HOUSTON, TX - WOOD PRESERVING WORKS - SWR 31547 – NOTIFICATION OF UTILITY ASSESSMENT – PRELIMINARY SCHEDULE

RE: RESPONSE TO COMMENT LETTER DATED AUGUST 31, 2021, AND UPDATED PROPOSED CITY OF HOUSTON STORM WATER SEWER ASSESSMENT WORK PLAN UNION PACIFIC RAILROAD COMPANY – HOUSTON WOOD PRESERVING WORKS HOUSTON, HARRIS COUNTY, TEXAS HAZARDOUS WASTE PERMIT/COMPLIANCE PLAN NO: 50343, ISWR NO 31547 EPA IDENTIFICATION NO TXD000820266; RN100674613/CN600131098

UPDATED PROPOSED CITY OF HOUSTON STORM WATER SEWER ASSESSMENT WORK PLAN

TITLE
 STORMWATER SEWER EVALUATION - LIBERTY ROAD

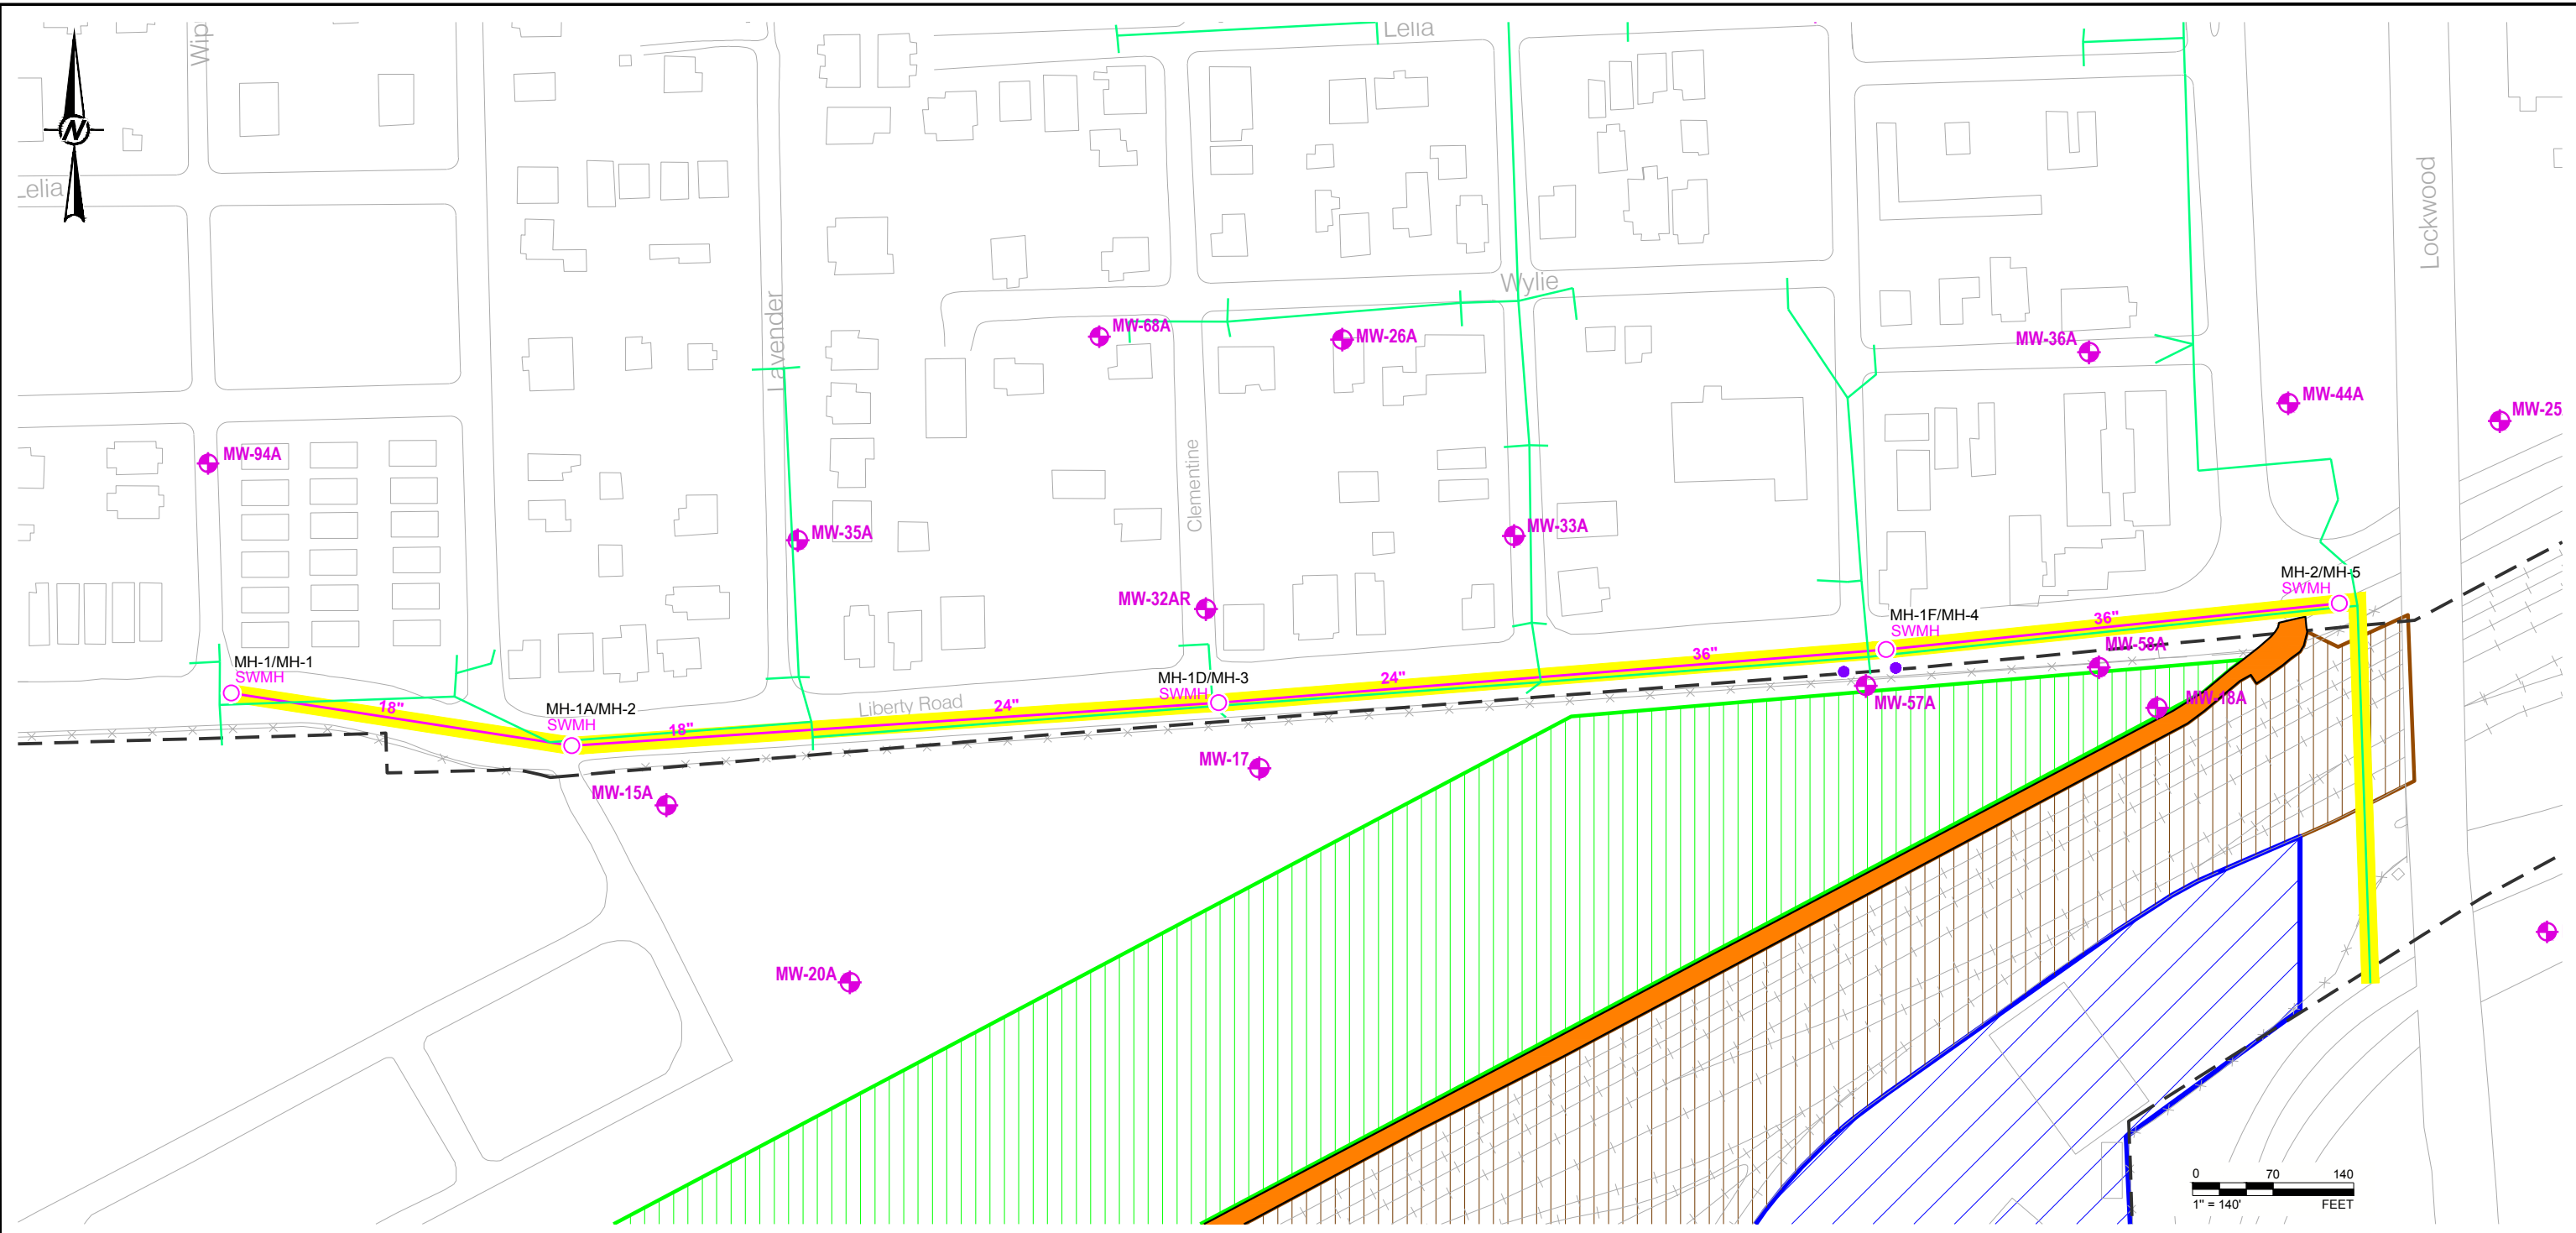
TCEQ Comment 1. A minimum of two additional monitor wells should be installed next to the Storm Drain in proximity to the A-TZ monitor wells containing non-aqueous phase liquid (NAPL) along the northern and eastern property boundary.

Response: As requested, UPRR will install two additional temporary wells near MW-57A in the approximate locations shown on Figure 1 (for a total of five temporary wells). The proposed locations may be adjusted based on field conditions (i.e., other underground utilities). These two additional temporary wells will be installed and plugged and abandoned following the procedures outlined in the scope of work presented below. It should be noted that, as indicated in the *DNAPL Recovery Activities*

Quarterly Report – 2nd Quarter 2021 dated July 28, 2021, and submitted to the TCEQ, none of the A-TZ wells along the northern and eastern property boundary have had measurable DNAPL since August 2015. Monitoring well MW-57A located along the northeast perimeter of the Site (see Figure 1) last had measurable DNAPL on August 3, 2015, following approximately 2.5 years of monthly manual recovery from the well.
